ADDENDUM NUMBER ONE (1)
Issued 05/19/2025

Project: Knights Mill Lift Station Rehabilitation

Project No. 25-07-704

RFI Responses for Knights Mill LS Rehab – Issued 05/19/2025

C-7
7 OF 7

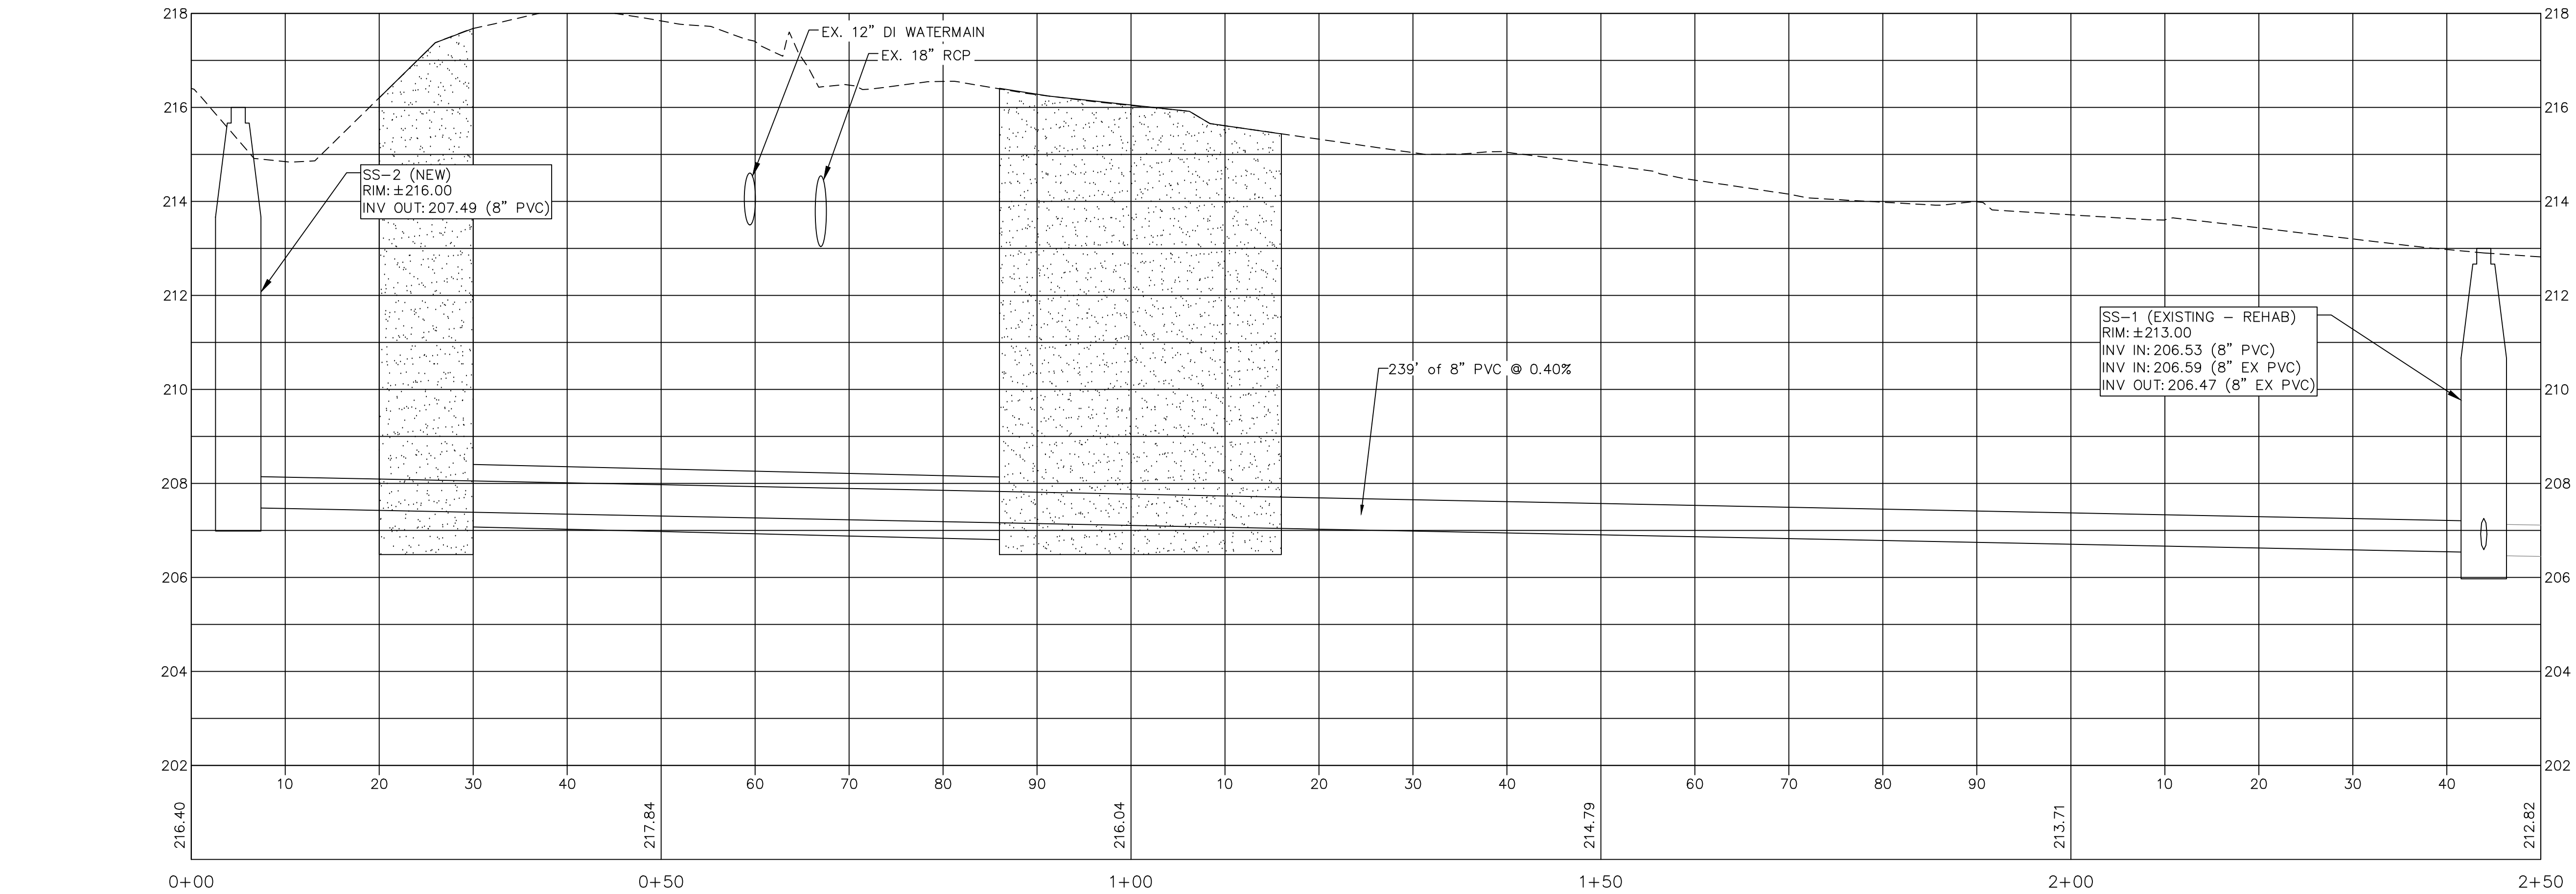
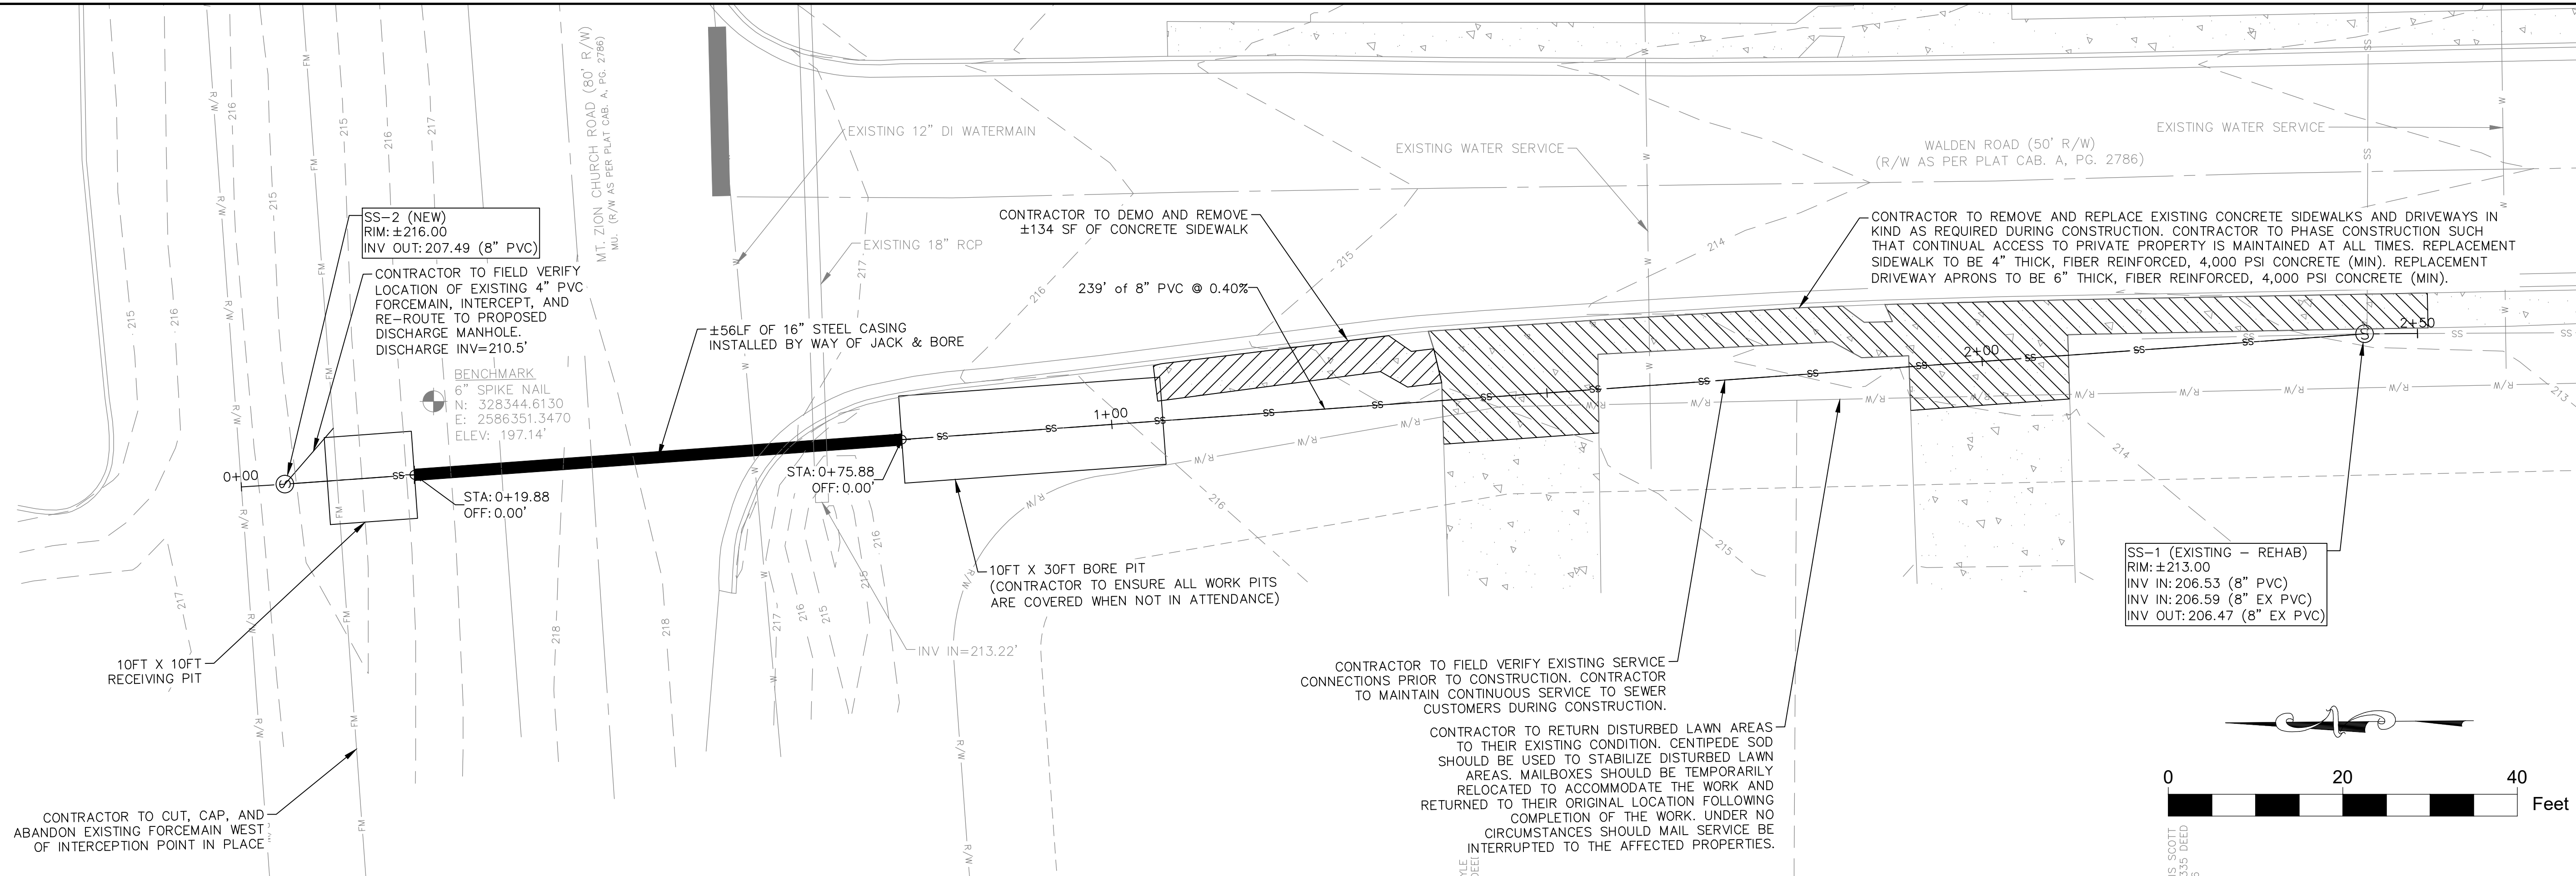
4. Sheet C-7. There is a manhole existing where plans call for MH#1. Is this manhole to be replaced or contractor to tie sewer to existing MH and Rehab existing MH?

7. 660G-Tie to Ex MH 12". Should this 8". No 12" PVC on this job.
 - a. CORRECT. SHOULD BE 8"; UCS/BID FORM IS REVISED AND REISSUED.
8. Can line item be added to bid form for 2-6" sewer services for note on sheet C-7 for 2 ex sewer services to be connected. And will cleanout be required at ROW on these?

- a. SS-1 IS EXISTING AND SHOULD BE REHABBED/LINED AS PART OF THIS PROJECT.
5. Is Existing MH at pump station lined or epoxy coated?
 - a. UNKNOWN. NEEDS TO BE REHABBED AND LINED AS PART OF PROJECT.

- a. YES AND YES. NOTABLY, SEWER SERVICE FOR RESIDENCE LOCATED NEAREST SS-1 MAY HAVE SERVICE ENTRY AT MANHOLE OR MAY HAVE SERVICE CONNECTION ON LINE. UNIT AND INSTALLED IMPROVEMENTS WILL BE BILLED BASED ON UNIT INSTALLED. UCS/BID FORM IS REVISED AND REISSUED.
